FILE NAME: Caunon Beach RFPD LOGNO. 04-96-0485

Re: Cannon Beach RFPD

File No. 04-96-0485 Facility ID. No. 2716

The Department of Environmental Quality (DEQ) has completed its review of the information submitted to date concerning the underground storage tank (UST) decommissioning and cleanup conducted at 232 North Spruce Street, in Cannon Beach, Oregon. The DEQ has determined that the cleanup appears to have met the requirements of Oregon Administrative Rules (OAR) 340-122-205 through 340-122-360 and that no further action is required at this time.

attemnts: Figure 1, proposed soil and groundwater interface sampling locations

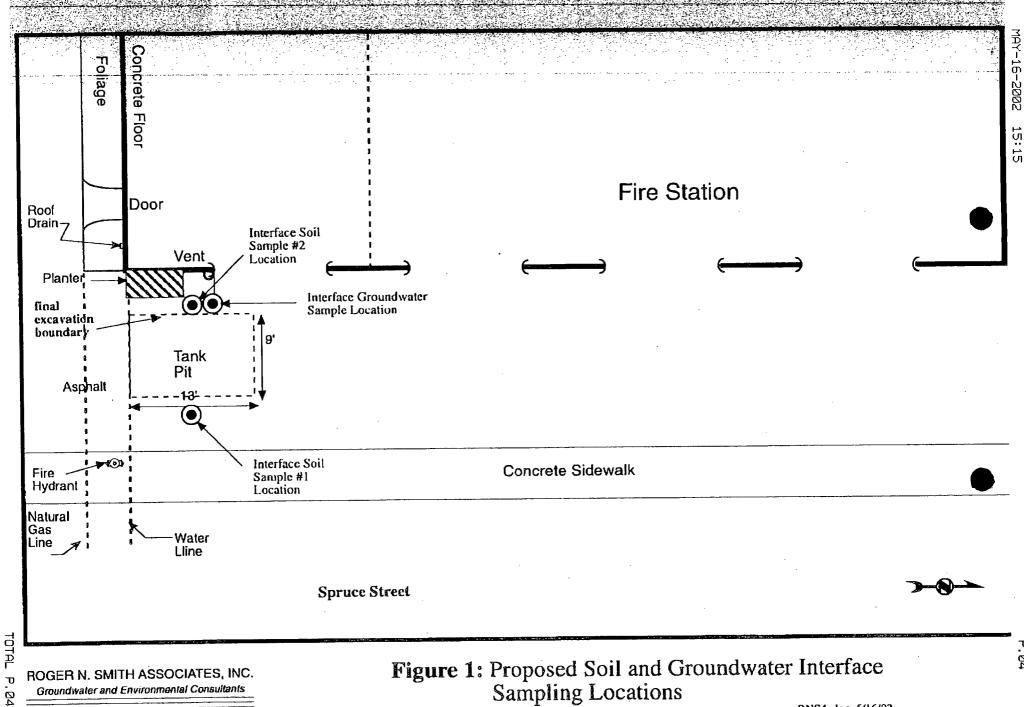
This is in response to our telephone conversation this morning about the plan presented to you on May 14th. This new Scope incorporates the changes discussed this morning (i.e. moving the groundwater sample) and collecting a soil sample from the soil remediation site. The remainder of the scope is the same as the May 14th version. It is our understanding that this work will supply sufficient information to the DEQ to receive an NFA on the property.

The field portion of the proposed work is planned for completion this week (Friday), with analytical results available by the following Friday (May, 24). We anticipate completion of the report and delivered to the DEQ before the end of May. It is presumed that the Fire Dept. will assure access (i.e. absence of parked vehicles) to the proposed sample locations.

atternnts: Figure 1, proposed soil and groundwater interface sampling locations

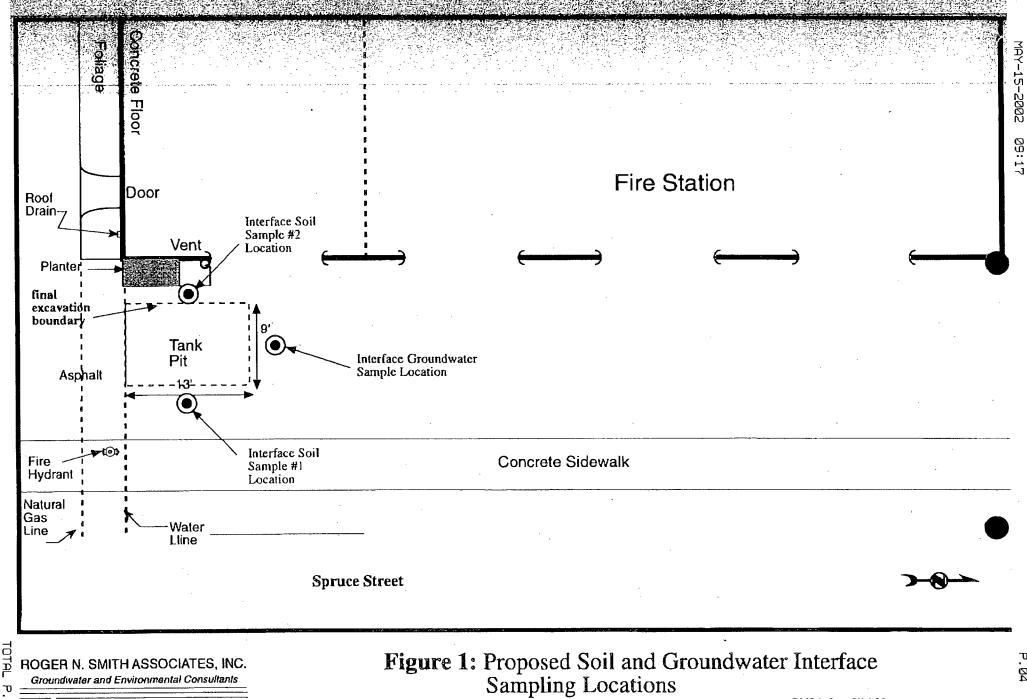
This letter is in response to your April 29, 2001 letter requesting additional information associated with the closure of an underground storage tank removed from an area in front of the former Cannon Beach Fire House at 232 North Spruce Street in Cannon Beach, Oregon.

The field portion of the proposed work is planned for completion this week (Friday), with analytical results available by the following Friday (May, 24). We anticipate completion of the report and delivered to the DEQ before the end of May. It is presumed that the Fire Dept. will assure access (i.e. absence of parked vehicles) to the proposed sample locations.

Figure 5: Soil Sample Results from Exploratory Phase

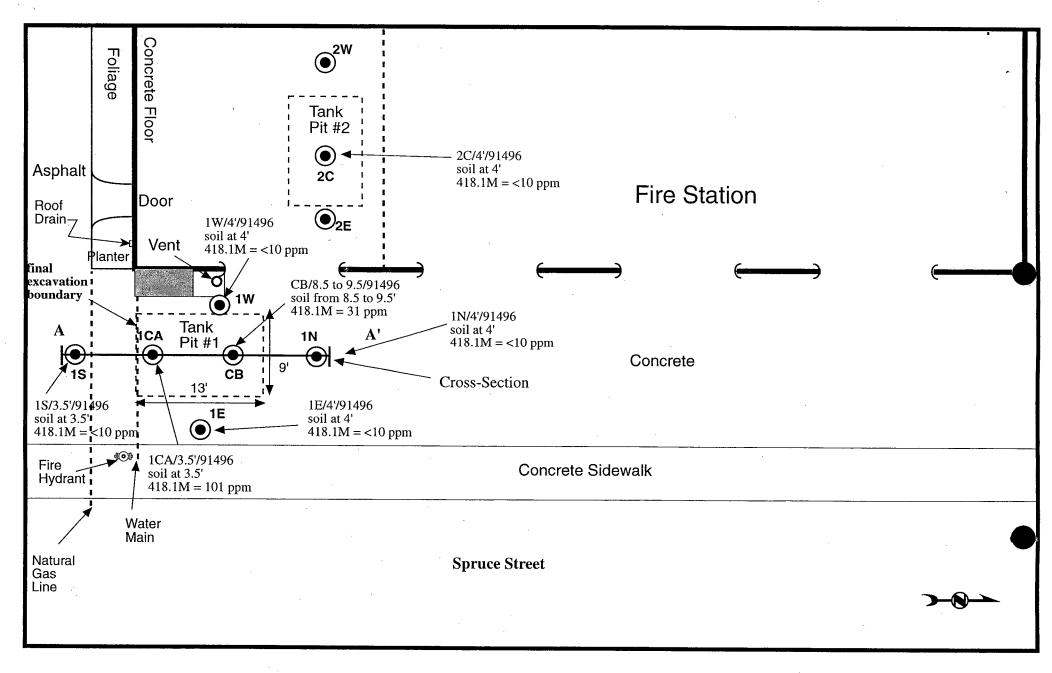
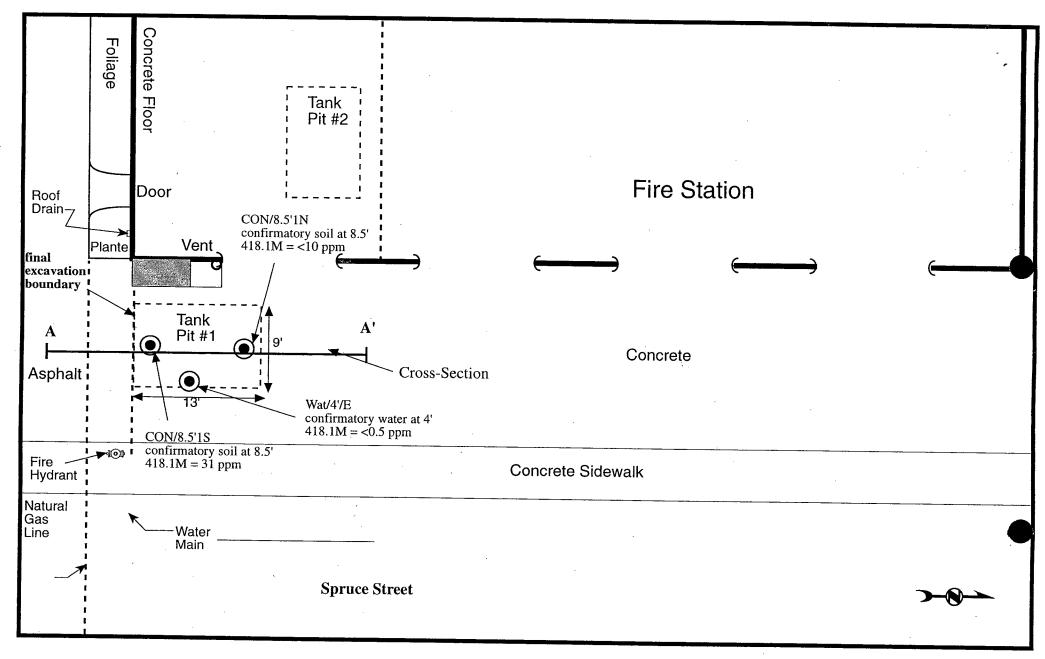
A site visit was made this month to confirm that the boundaries of the pit excavation were correctly identified on the maps. These boundaries are shown in Figures 4, 5 and 6). Item #1 in your 10/17/01 letter requested that a map be submitted showing limits of the excavation. Figures 2 and 3 show the vertical extent of the excavation and Figure 5 shows the final lateral excavation boundaries.
